# 17-114ARB-MPR – VINE AND TAP SIGN

A Minor Project Review (MPR) for a wall sign for an existing tenant space.

**Staff Recommendation**

Approval of Minor Project Review with 3 conditions.

### 3. Sign Plan

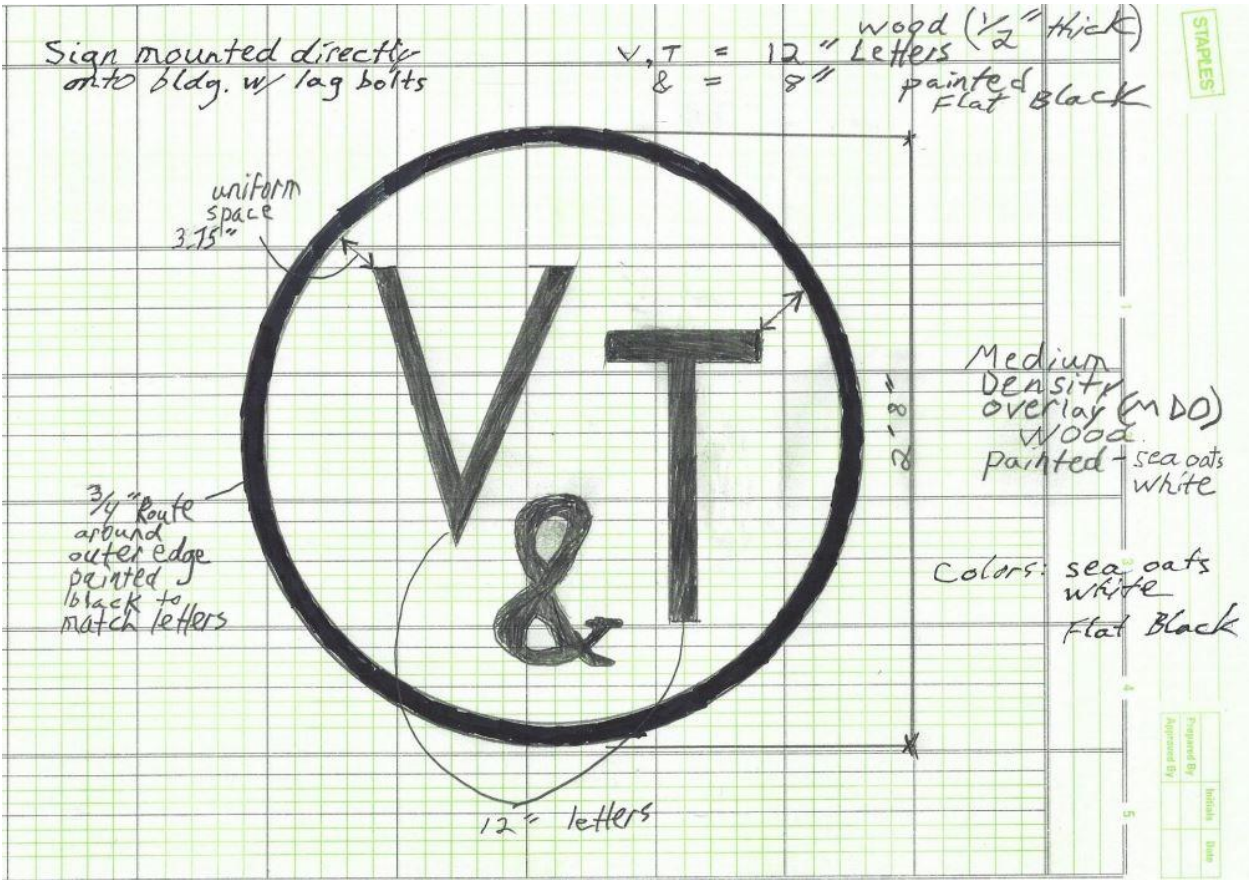
This is a proposal for the installation of a new wall sign for an existing tenant space within Historic Dublin. The circular, routed sign will be located on the front of the building facing the parking lot. For this proposed wall sign, Code permits a maximum sign size of 8 square feet and a maximum height of 15 feet, or not extending above the sill of the second story window; whichever is lower. The sign is proposed to be 8 square feet and 8 feet in height. The proposed sign will be a single-faced, MDO (Medium Density Overlay) or plywood sign which is not a permitted material, and need to be revised. High Density Urethane (HDU), cedar, redwood, treated lumber and equivalent materials are required. Signs must be

properly sealed to prevent moisture from soaking into the wood. Code requires signs to be limited to three colors. The proposed sign includes two colors: Sea Oats White for the background and Flat Black for the routed areas and letters, which meet Code. This application does not include any proposed window signs. The applicant proposed the sign be affixed to the building with lag bolts. Planning recommends the sign be affixed to the building at the back of the sign with all hardware concealed.

- 1) The character and materials are compatible with the context.**  
Criteria met with conditions. The proposed MDO material is not a permitted material. The applicant should revise the plans and select a permitted wood material (HDU, cedar, redwood, treated lumber or equivalent material) for the sign background and lettering. Planning recommends the sign be affixed to the building at the back of the sign with all hardware concealed.

- 8) Sensitively maintained historic building materials.**  
Criteria met condition. The proposed MDU is not a permitted material within the zoning district. The applicant is required to use a permitted wood material for the sign (HDU, cedar, redwood, treated lumber or equivalent material) within the Historic District.

- 1) That the applicant use a permitted wood material for the sign background and lettering (HDU, cedar, redwood, treated lumber or equivalent material).
- 2) That the sign be affixed to building at the back of the sign and all hardware be concealed.
- 3) That any future permanent window signs for the tenant space be reviewed and approved by the Architectural Review Board (ARB) prior to sign permitting and installation.
